# MANUAL CHANGES

CHANGE DATE: April 21, 1980

INSTRUMENT: 5061A Cesium Beam Frequency  
Standard Operating and Service Manual  
SERIAL PREFIX: 1740A  
DATE PRINTED: JUN 1978  
HP PART NO: 05061-9052  
MICROFICHE NO: 05061-9053

(This change supersedes all earlier dated changes)

Figure 1. Signal Wiring Diagram (Serial Prefix 1740A)

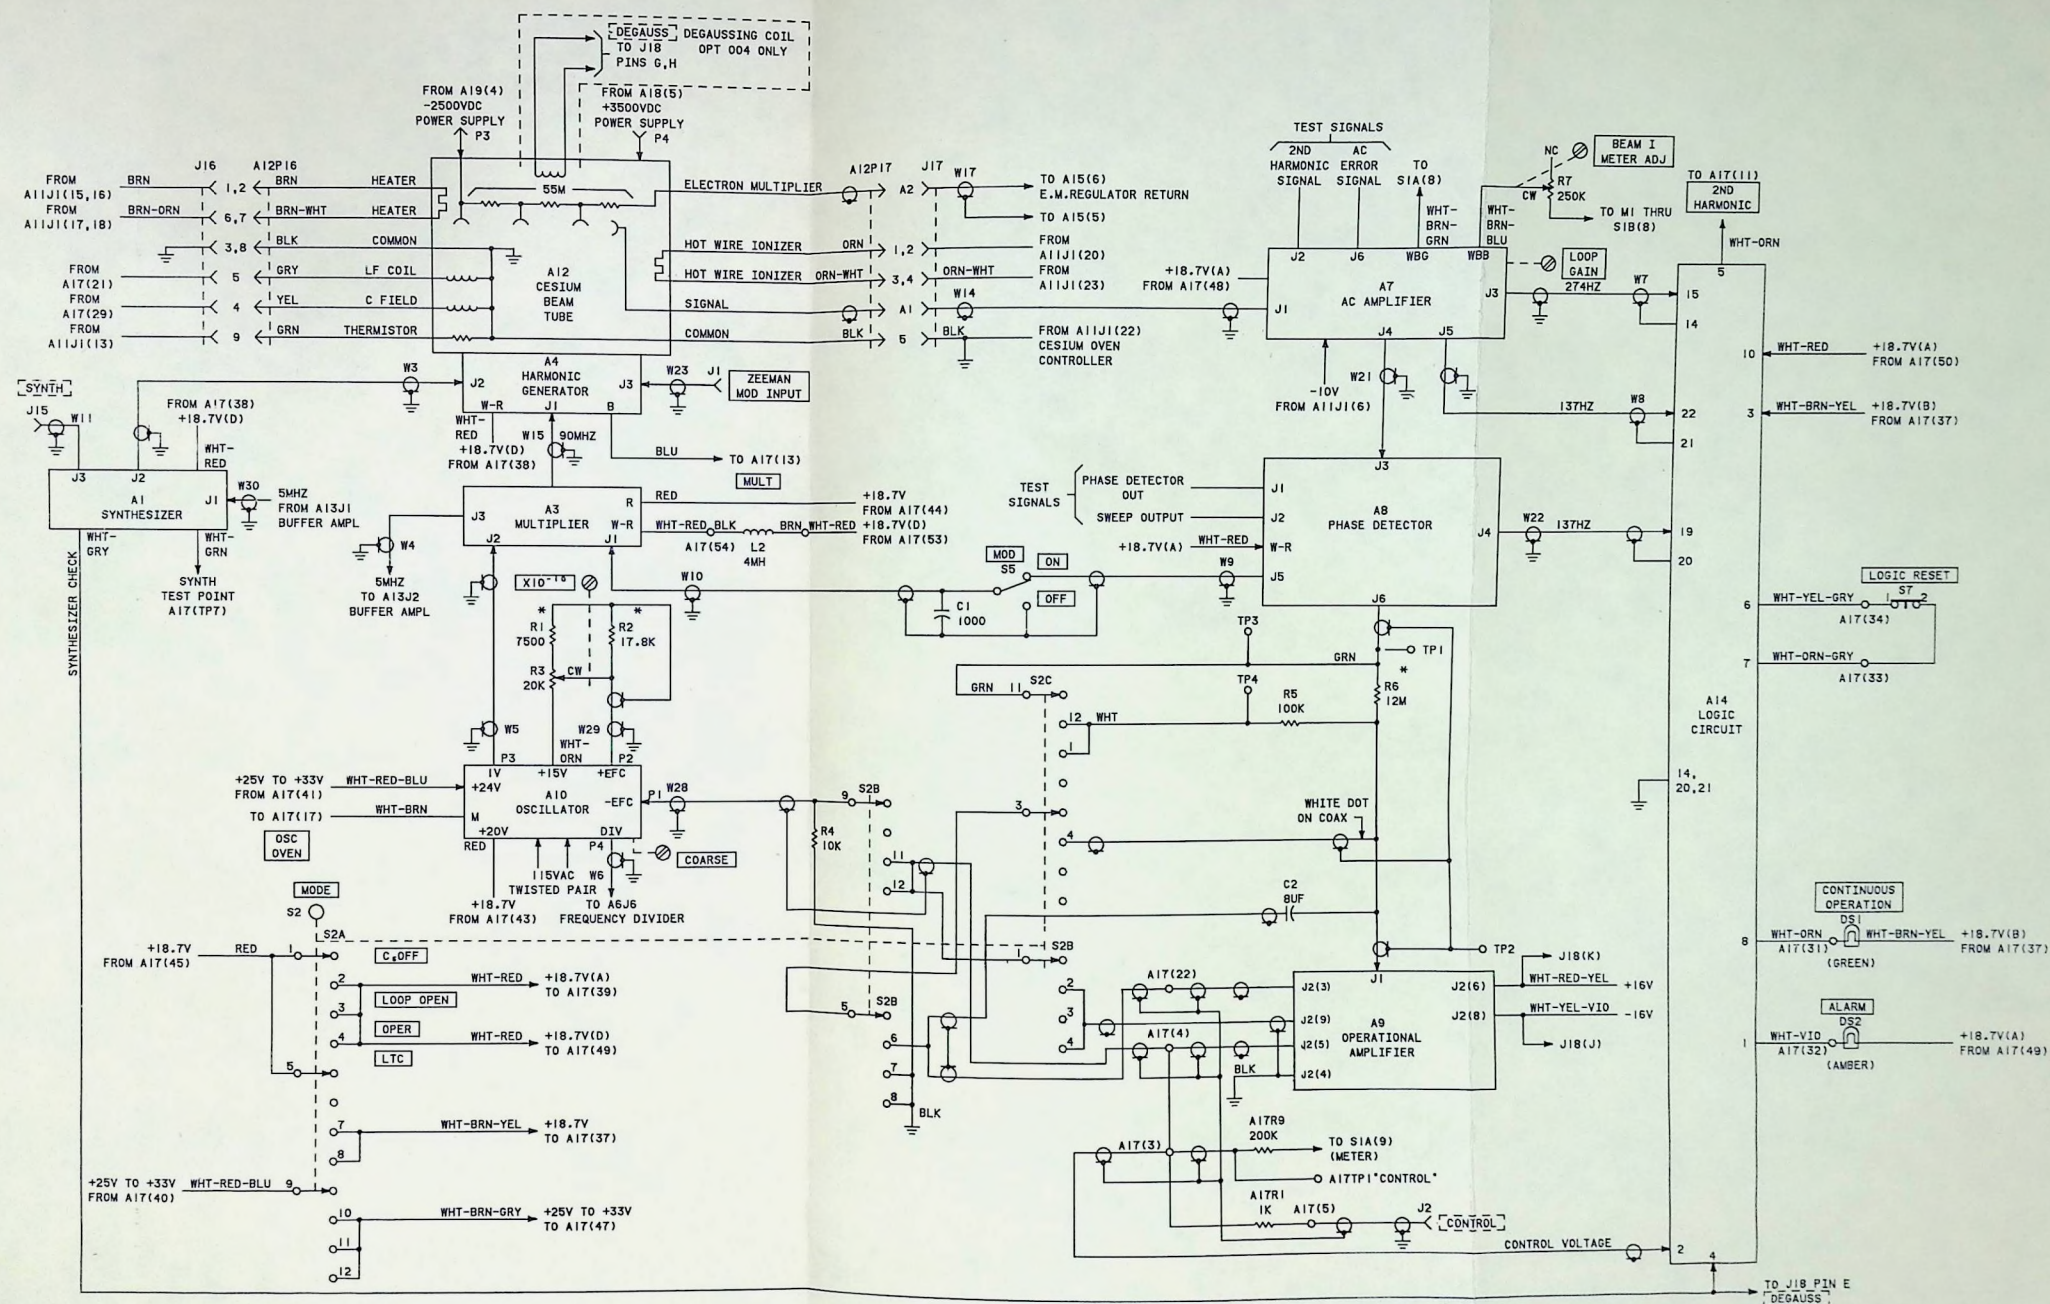
Page 8-5, Figure 8-5, Wiring Diagram:

Replace with attached Figure 1 Signal Wiring Diagram (Serial Prefix 1740A).

Figure 2. A9 (05061-6134 Series 1740) Operational Amplifier Schematic Diagram

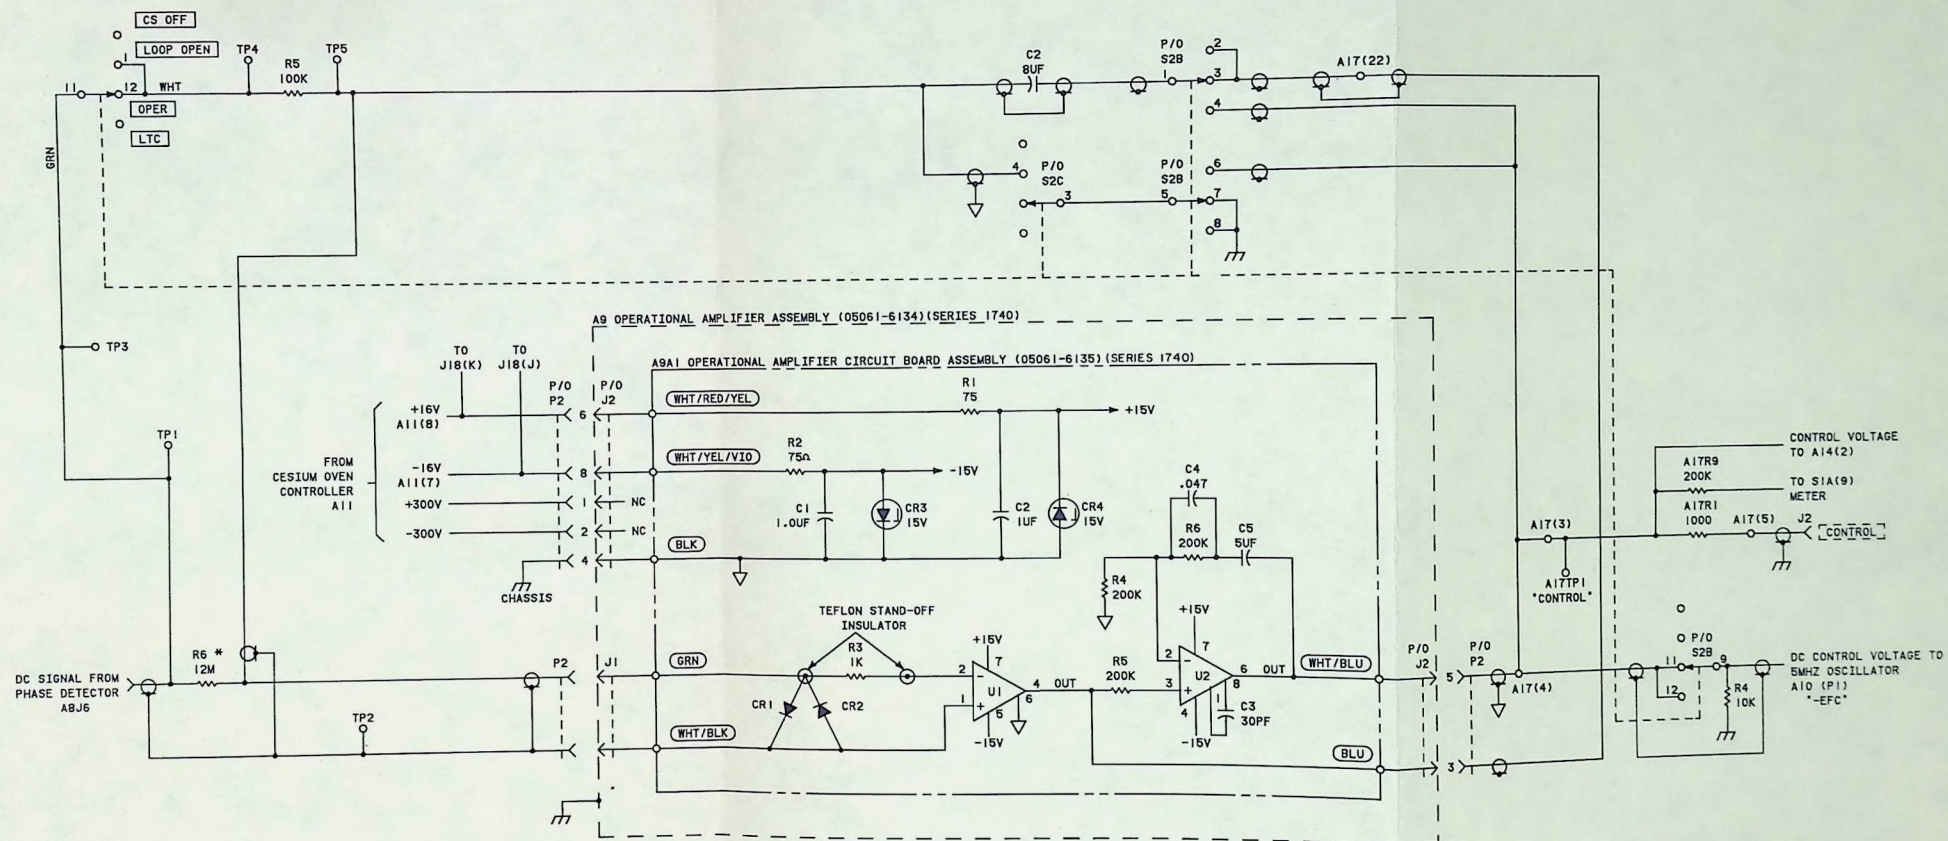
Page 8-35, Figure 8-20, A9 Schematic Diagram:

Replace with attached Figure 2. A9 (05061-6134 SERIES 1740) Schematic Diagram.
